Minutes of **61st PCC meeting**

EASTERN REGIONAL POWER COMMITTEE

MINUTES OF 61ST PROTECTION SUB-COMMITTEE MEETING HELD AT ERPC, KOLKATA ON 28.11.2017 (TUESDAY) AT 11:00 HOURS

MENDHASAL SYSTEM, Closing attempt on MSAL-1 and actuation of SOTF, due to fault on LINE-3 and BREAKERS in close condition at CHANDAKA

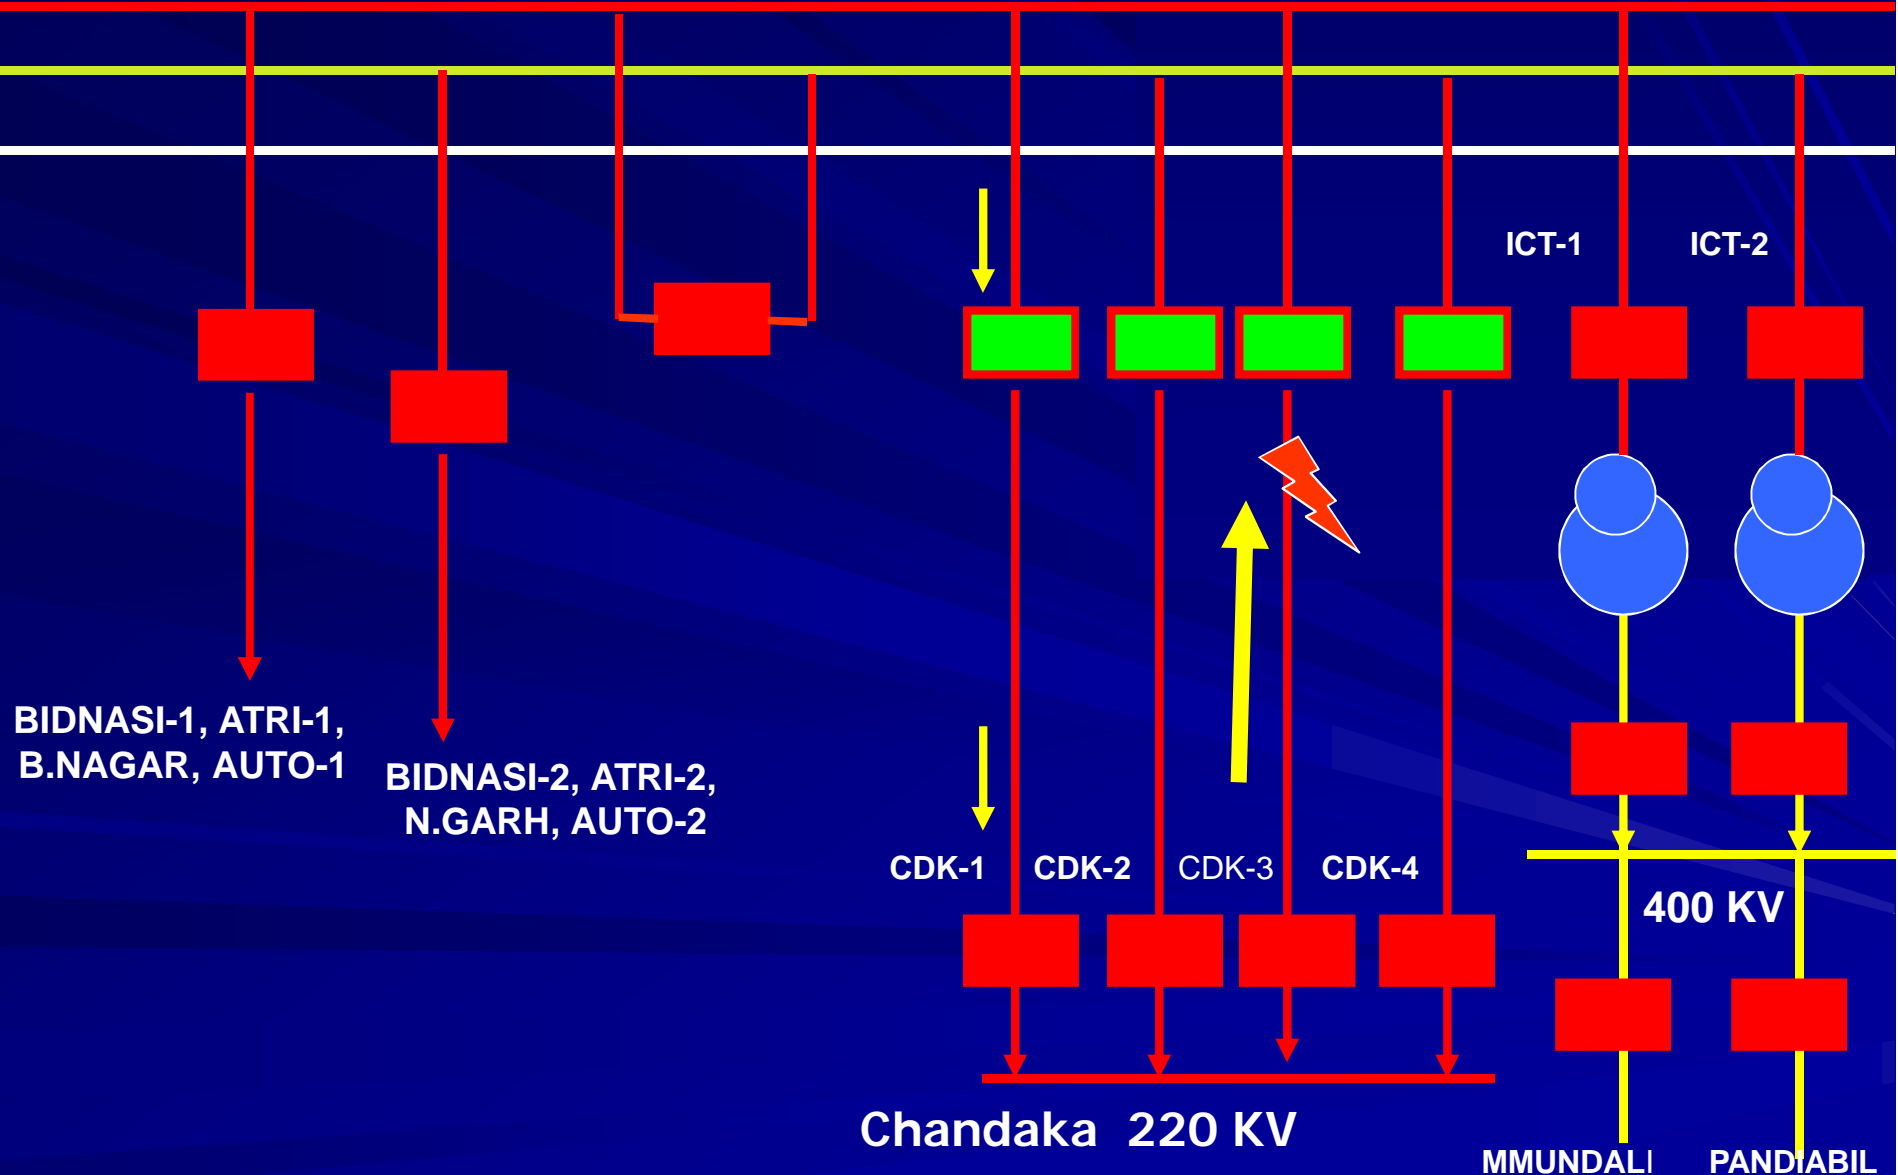
1. **R-Ph TREE TOUCH Earth fault** on 220KV Mendhasal-Chandaka line No3 at 15Kms from Mendhasal, resulted correct tripping on Zone-1 at Mendhasal end, **but did not trip at Chandaka end (due to DP relay Error) and IDMT feature on DIRECTIONAL BU relay and delay actuation as compared to relays at Mendhasal end.**
2. The NON-TRIPPING of this feeder at Chandaka end and fault persistence in the system, caused tripping of all the feeders (Line-1,2 and4) at Mendhasal on Back up relay on HS feature.
3. Relays at Chandaka end did not actuate due to fault in REVERSE ZONE and CHANDAKA was radially fed from Mendhasal only.
4. DP Relays on other feeders at Mendhasal end initiated only on Zone-2 because of RESISTIVE fault, but tripped on Directional Back up relays on HS feature.

1. Planned for replacement of FAULTY DP RELAY at CHANDAKA END on MDSL- CDK Line-3. The relay was replaced on 18.10.17.
